Basement Impact Assessment
Audit

For
London Borough of Camden

Project Number: 12336-40
Revision: F1

Last saved	25/05/2017 10:46
Path	GHajm12336-40-250517-47 Doughty Street-F1.doc
Author	G Harper, BEng PrEng
Project Partner	E M Brown, BSc MSc CGeol FGS
Project Number	12336-40
Project Name	47 Doughty Street
Planning Reference	2016/1027/P & 2016/1183/L

E&P
SK16
Structural details of Basement Junctures
2017.02.15 JET

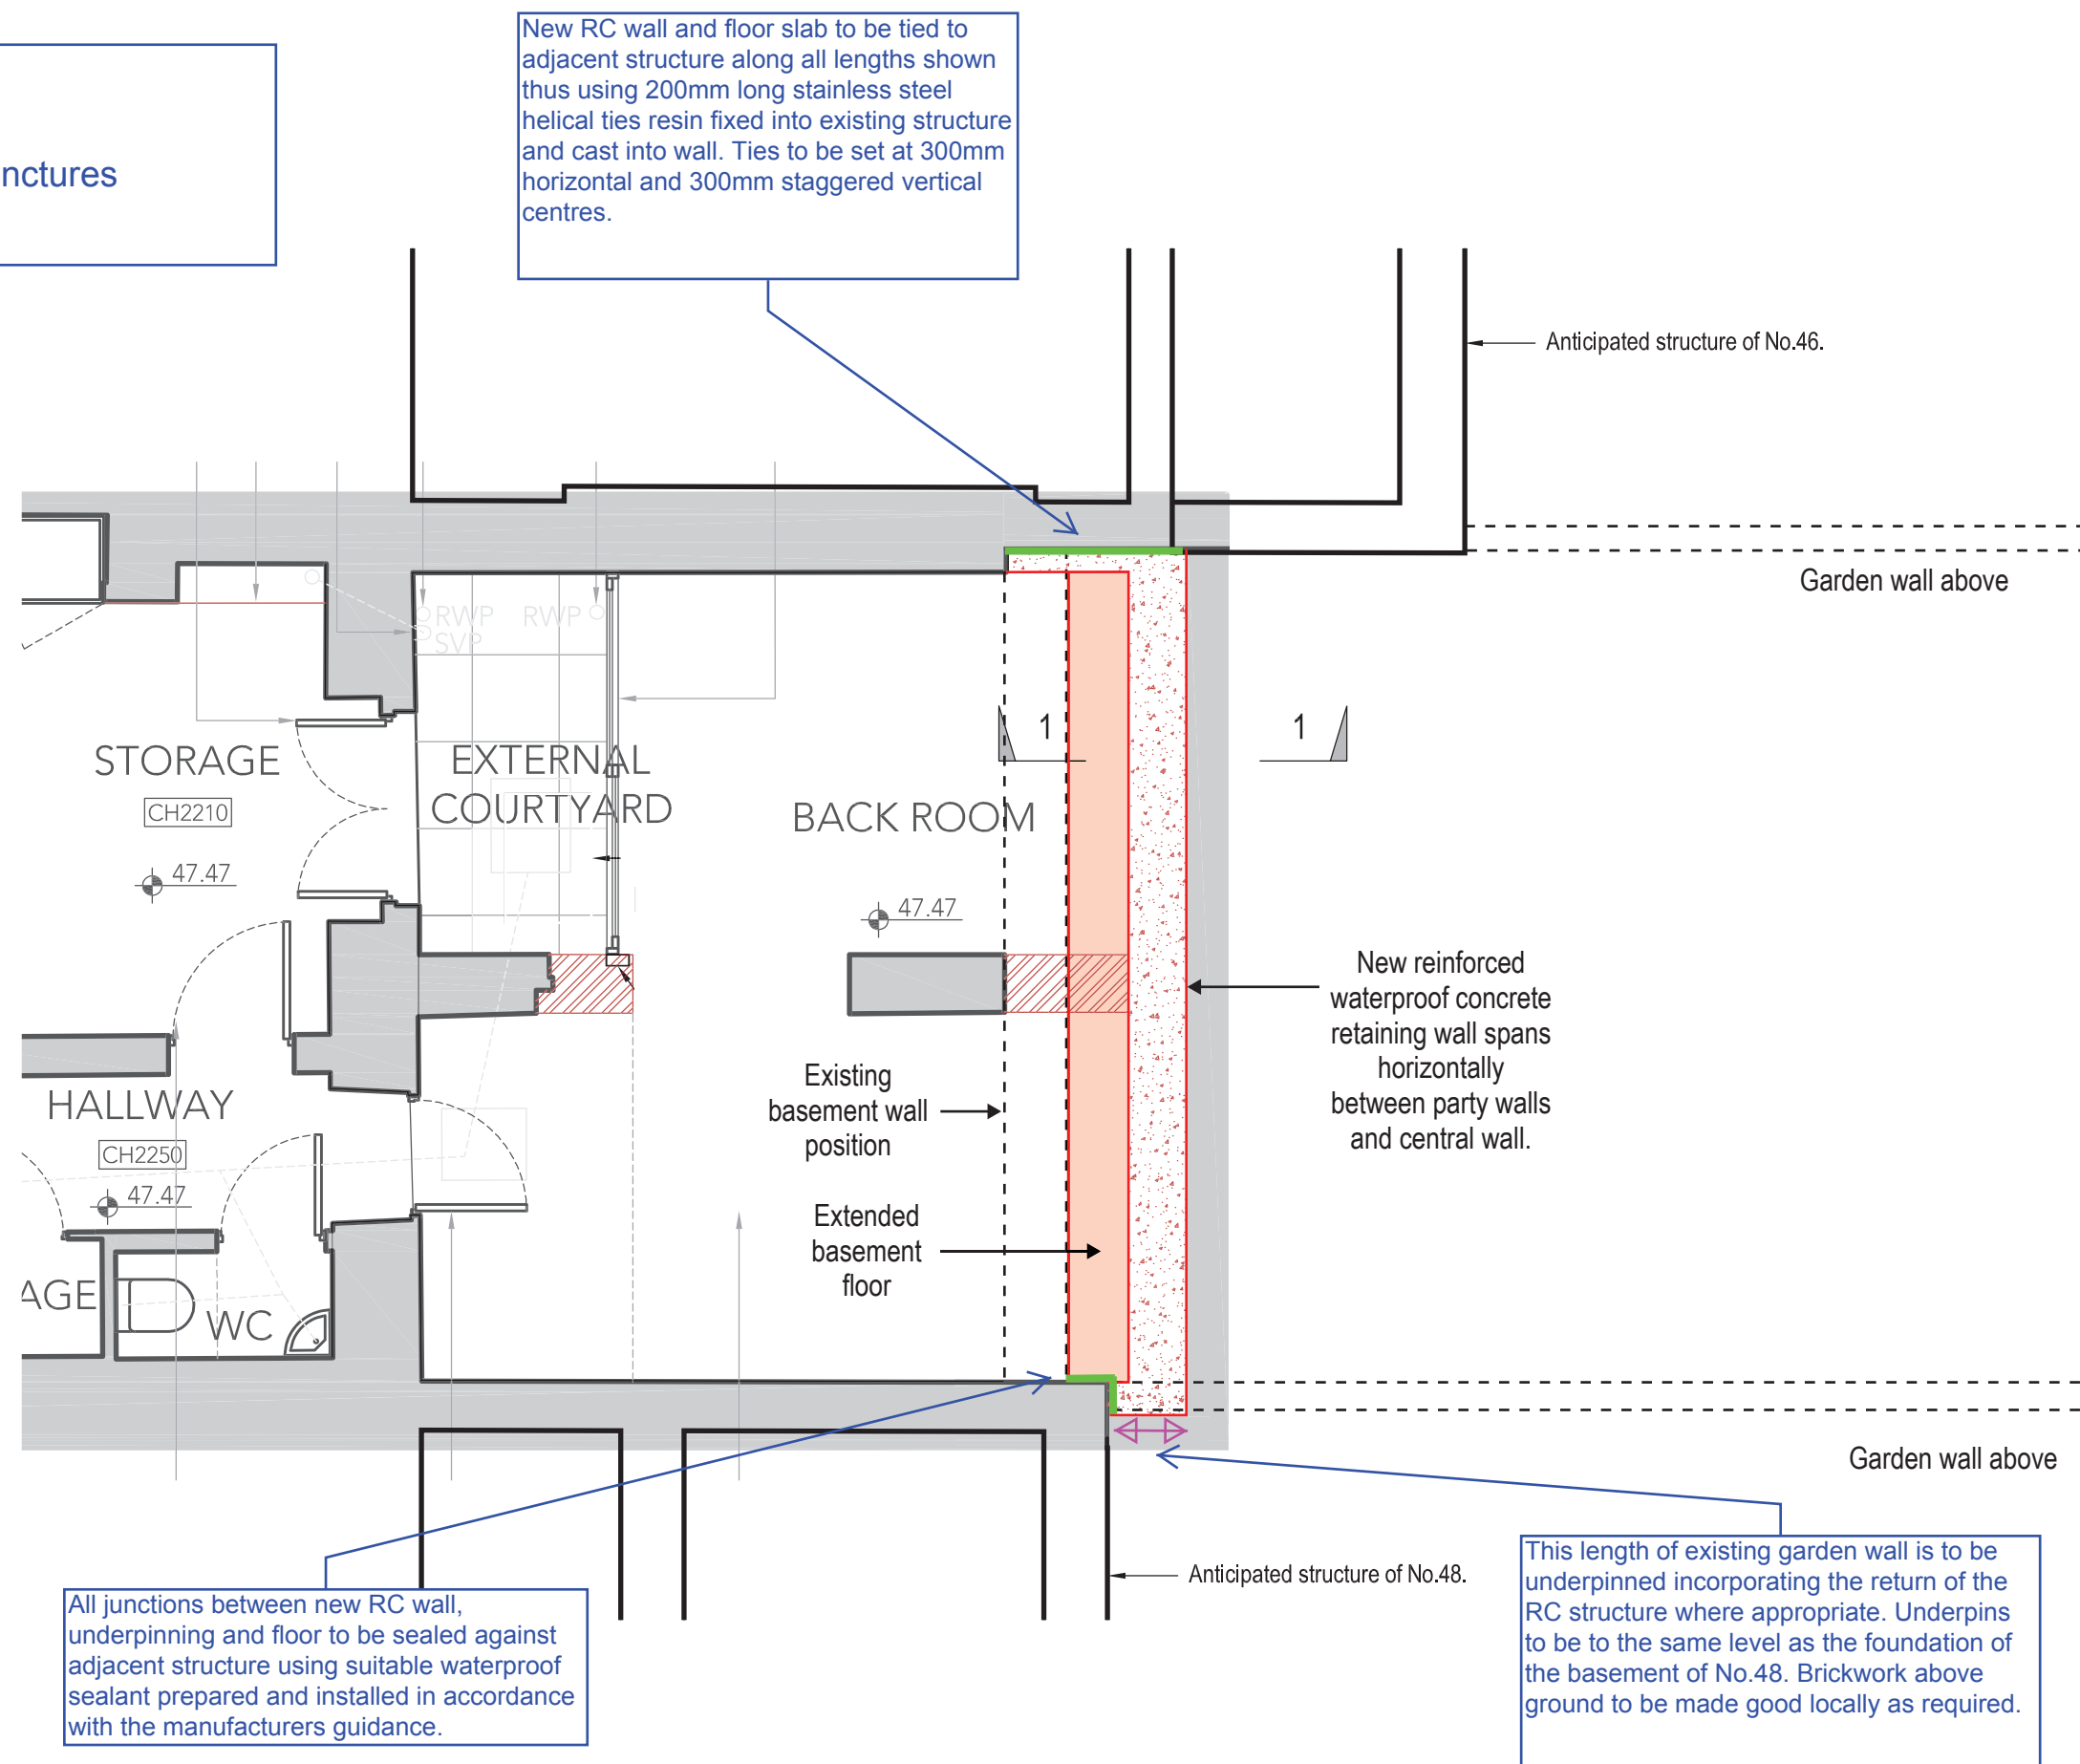
2) Please provide calculations for the design of the new retaining wall, including proposed connection details to both the Party Walls and all associated temporary works proposals and construction sequencing drawings.

Calculation pages BW 1-4 are attached in Appendix B together with a copy of SK 16 which provides structural details of the basement junctions. More detailed CAD drawings will be produced in due course. We have also attached a copy of our Temporary Works Proposal

(BIA states wall spans horizontally)
but design for ^{max} BM of 76 kNm.

$$A_{sreq} = \frac{K \times f_{cu} \times b \times d^2}{0.87 \times f_y \times z} = \frac{76 \times 10^6}{0.87 \times f_y \times z} = 959 \text{ mm}^2/\text{m}$$

Provide 16 ϕ @ 200 c/c = 1010 mm²

both directions & both faces

for wall to span horizontally or vertically.
